#### AMENDMENTS KEY:

| 1   | 20/07/20 | Issued to show EWA changes | SR | 145     |

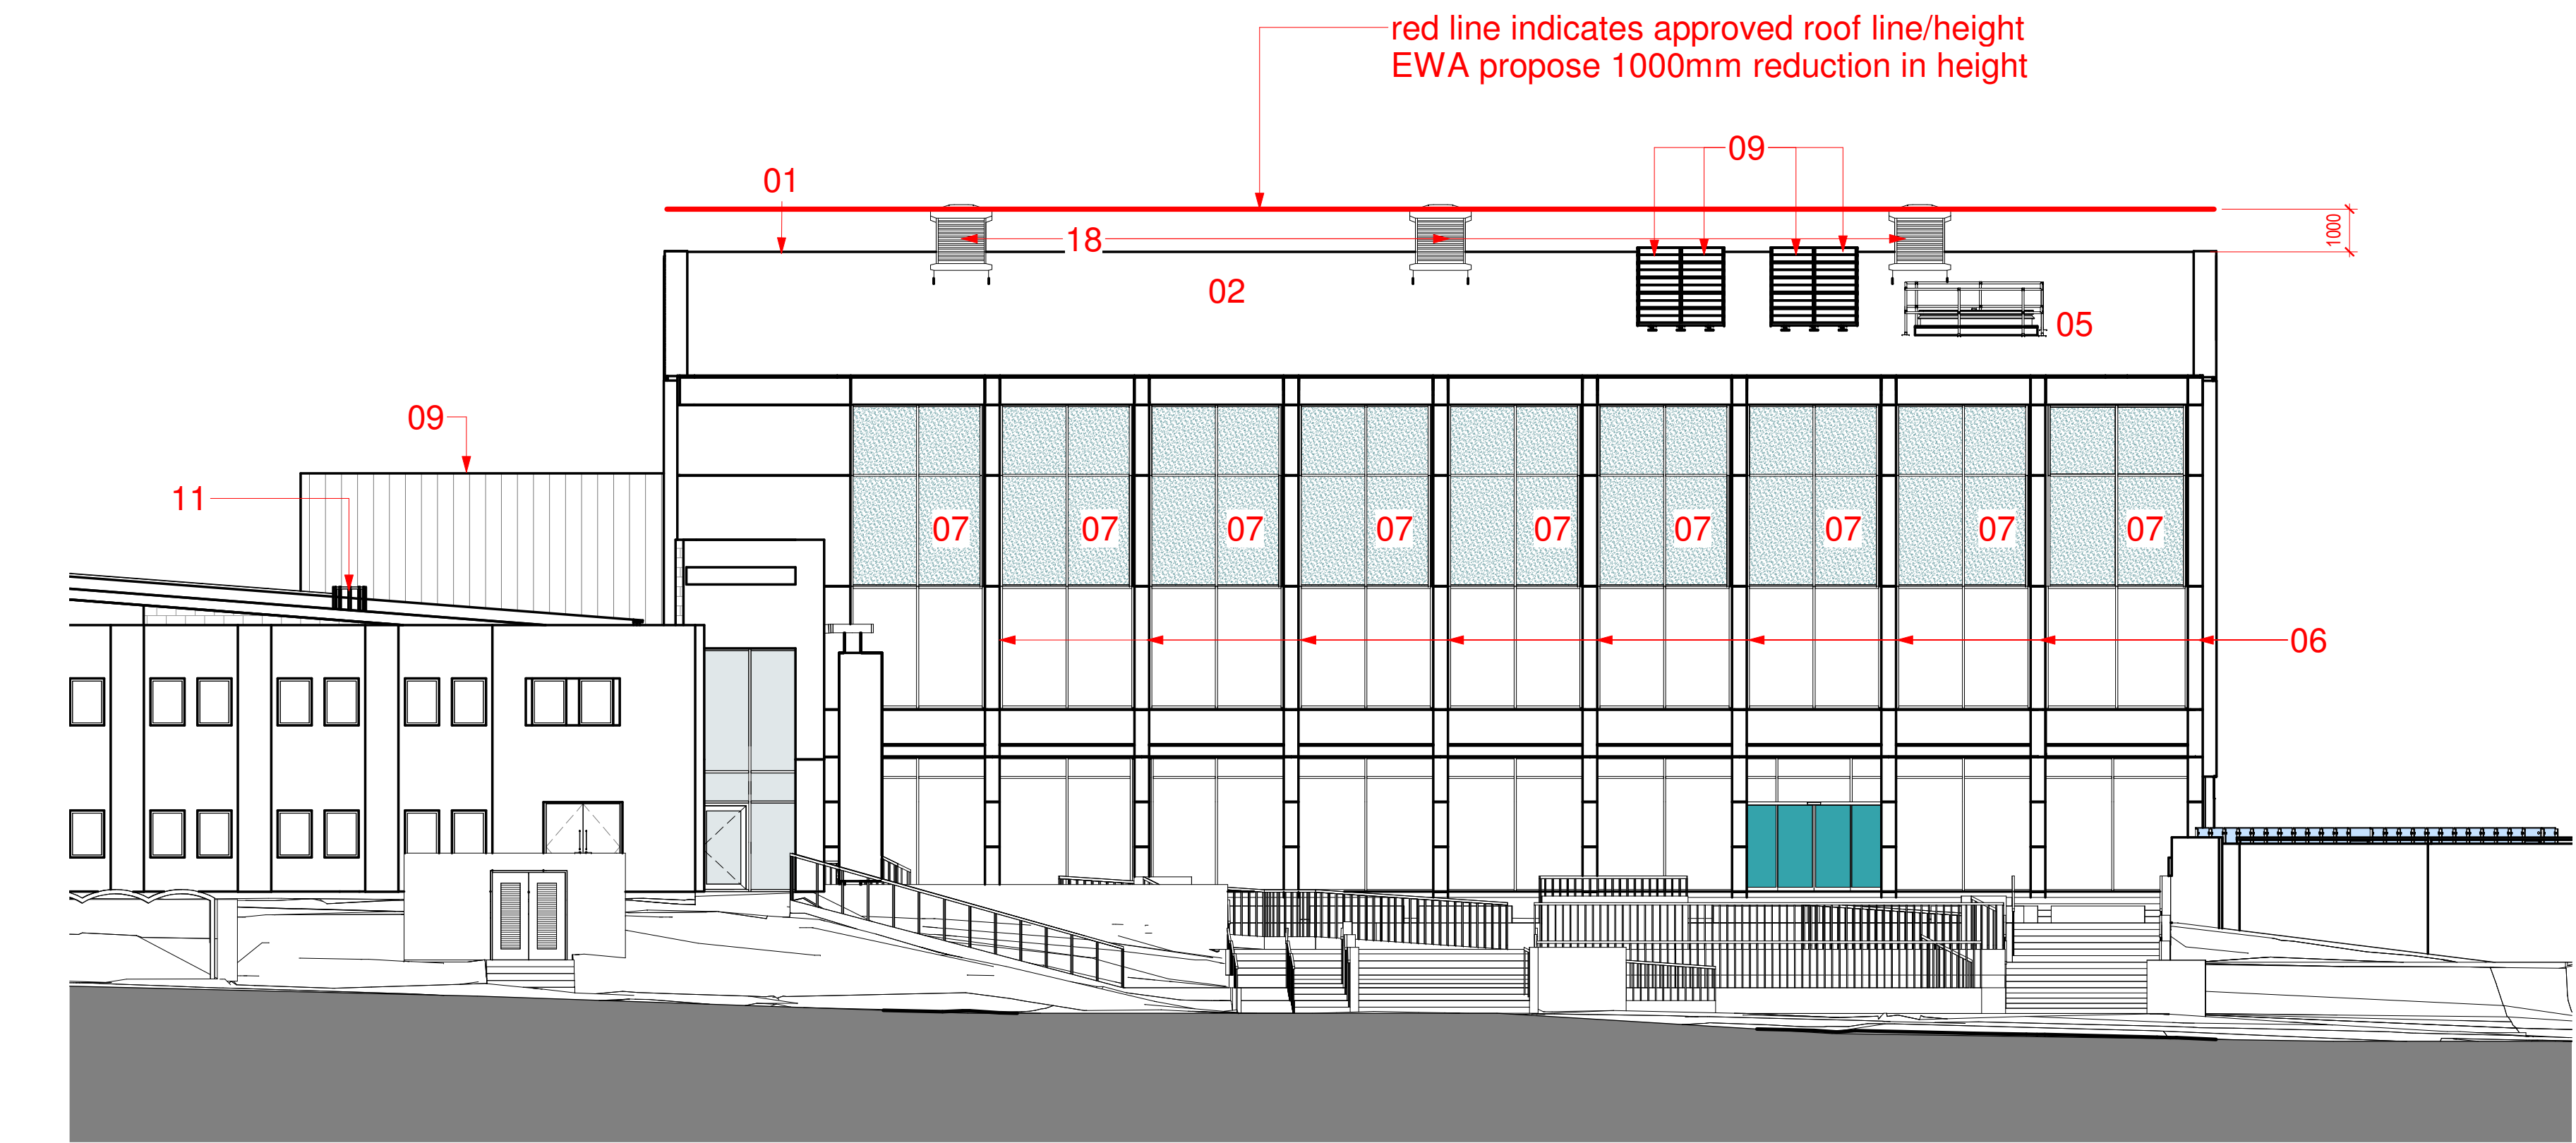
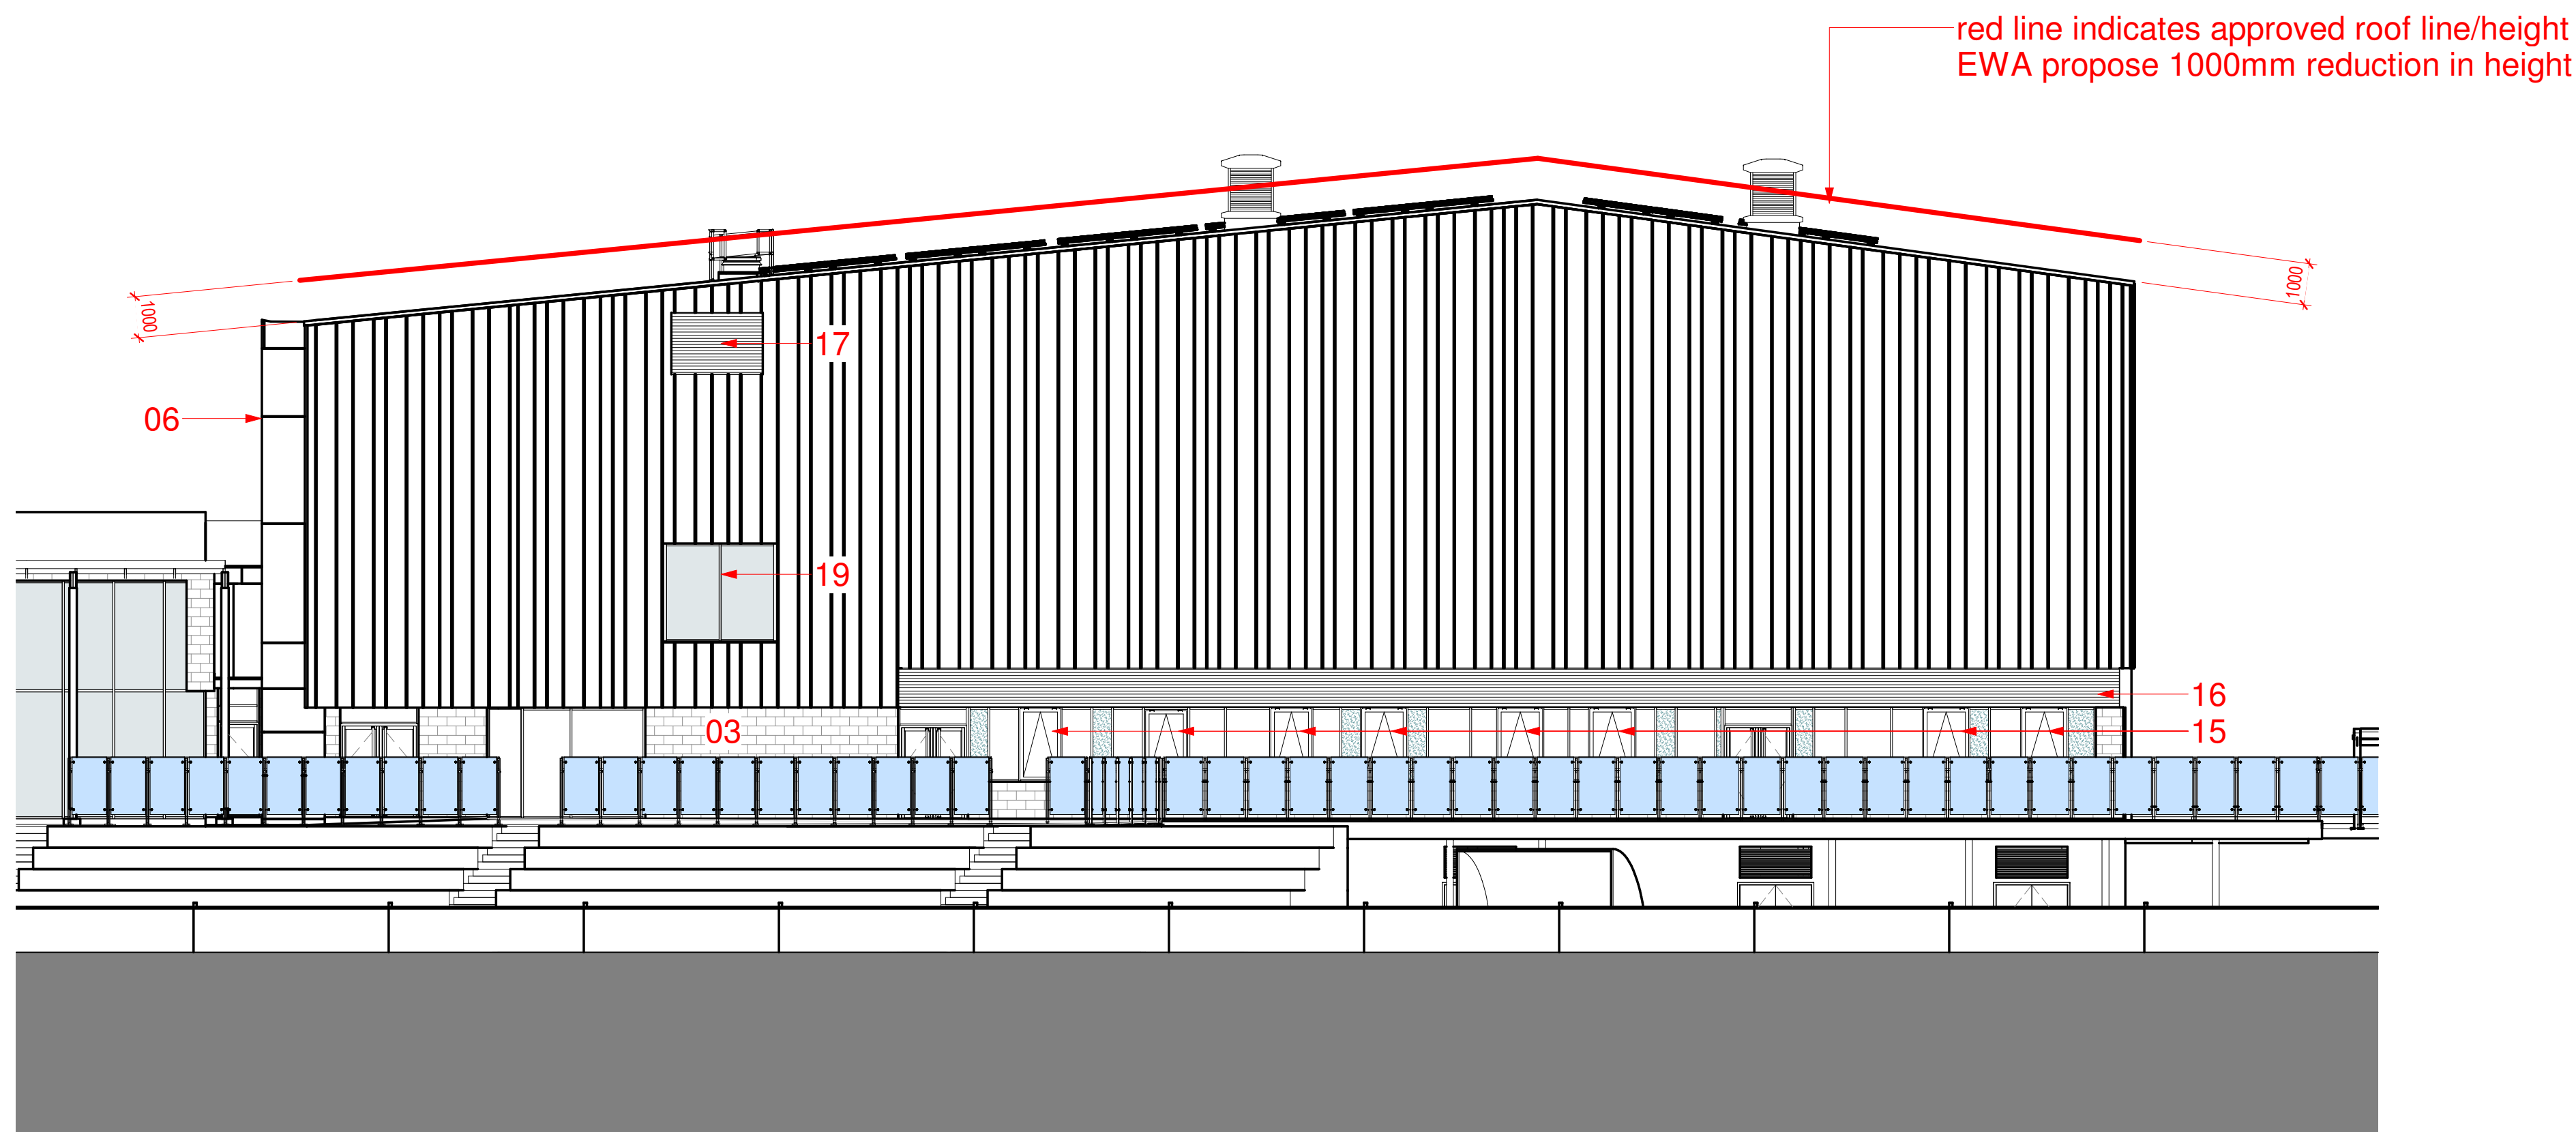
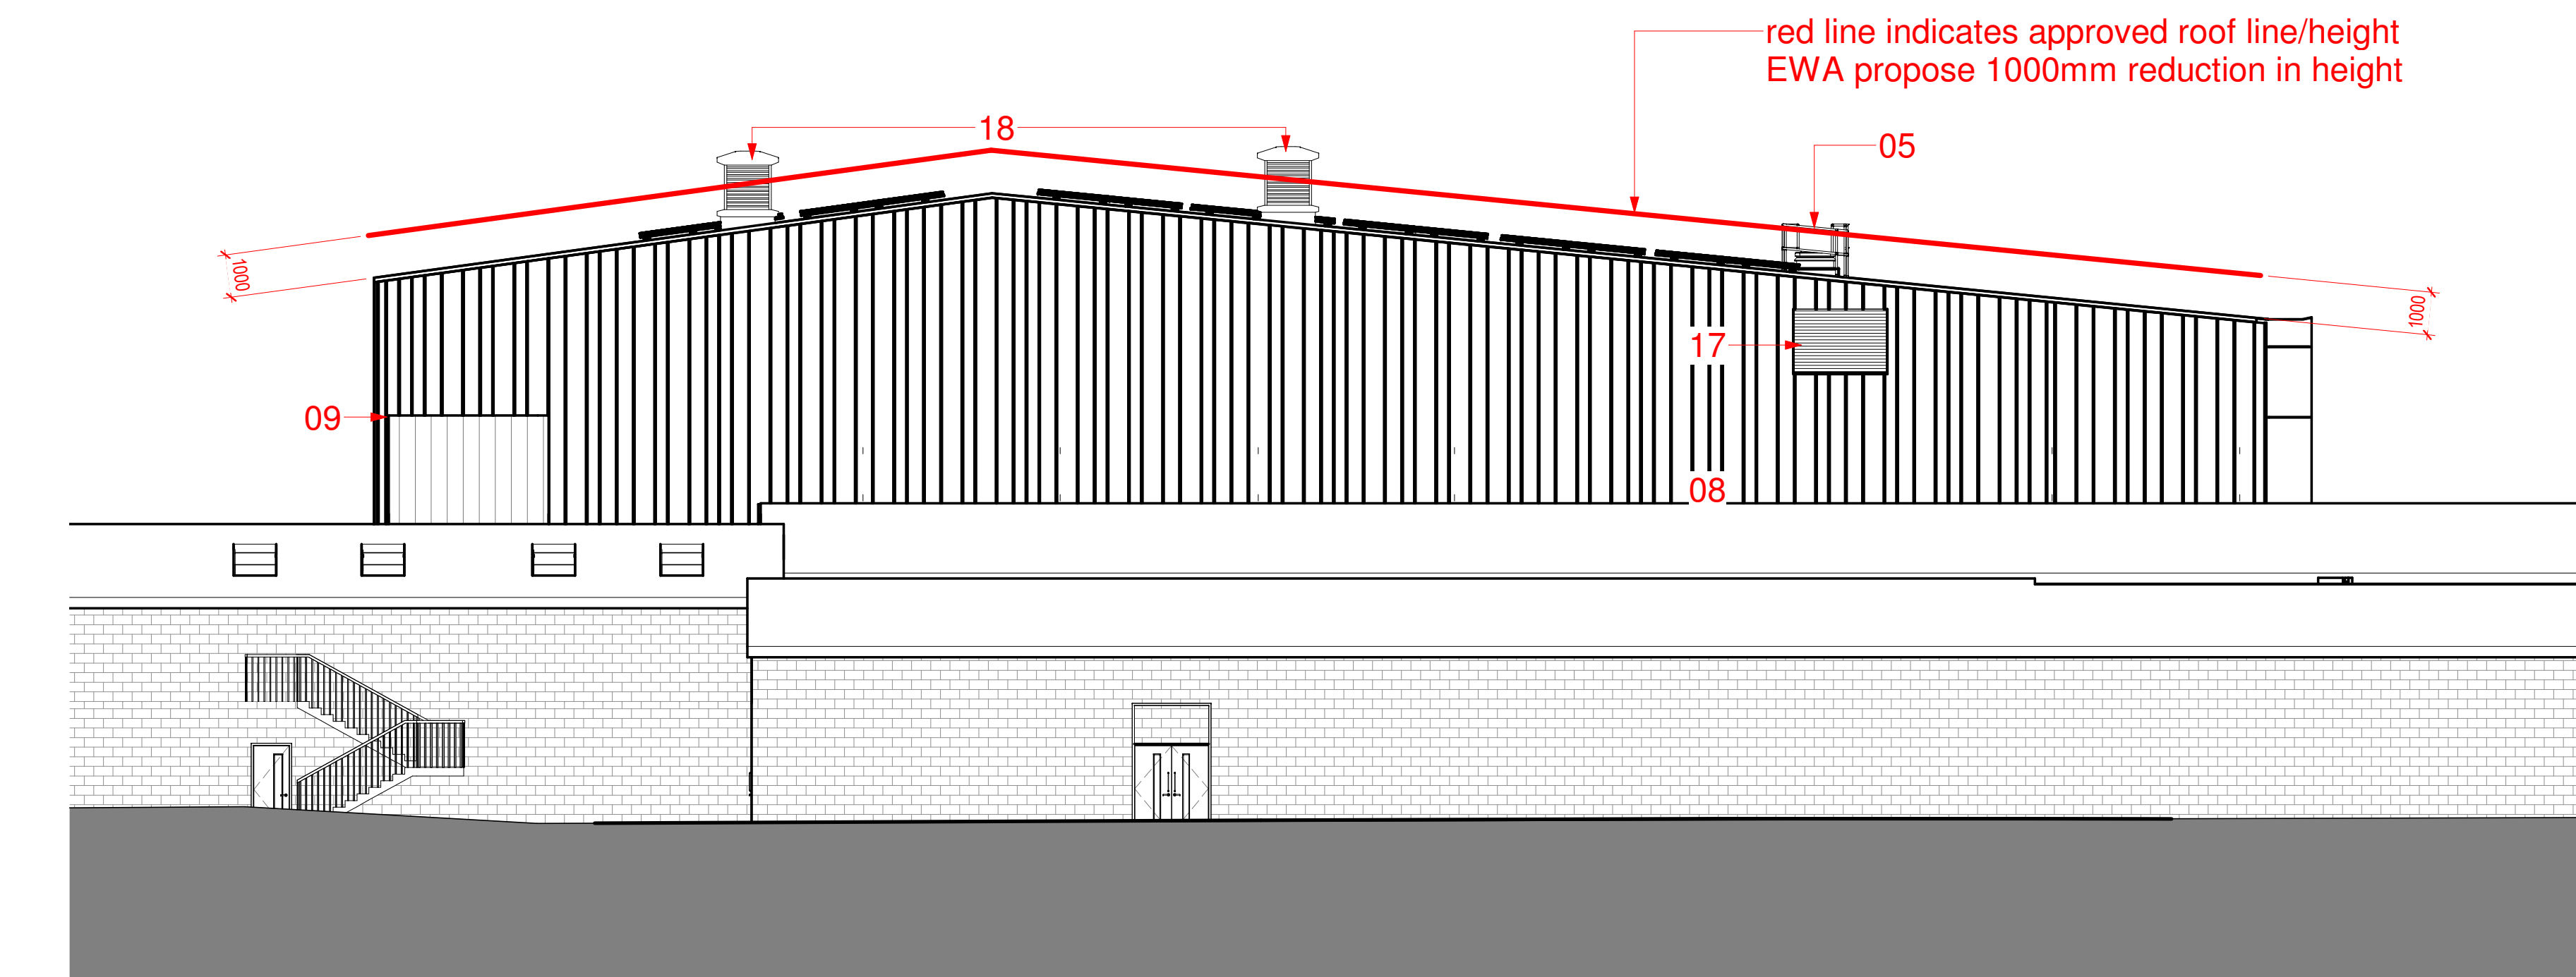
- 01 - A 1000mm Reduction in Building Height to sports hall
- 02 - Omission of Sports hall rooflights
- 03 - Blockwork introduced – reduction of Kalzip
- 04 - Blockwork plinth to the compound

- 05 - Addition of Access hatch and roof access system
- 06 - North Façade change from Render to equitone boards and stone panelling
- 07 - Change of polycarbonate to opaque glazing

- 08 - Omission of access from plant room to workshop roof
- 09 - PV units added
- 10 - Reduction to Rooflights to Workshop
- 11 - Access ladders to Workshop Roof

- 12 - Canopy as cantilever instead of posted
- 13 - Re configuration of Stepped Terrace levels
- 14 - Increase of compound area to abut the staircase walling

- 15 - Purge vents into the linear windows
- 16 - QED louvres to façade
- 17 - Reduced size of louvres to East & West Elevations
- 18 - Added Ventilation chimneys to sports hall roof

- 19 - Introduction of mullion to picture window
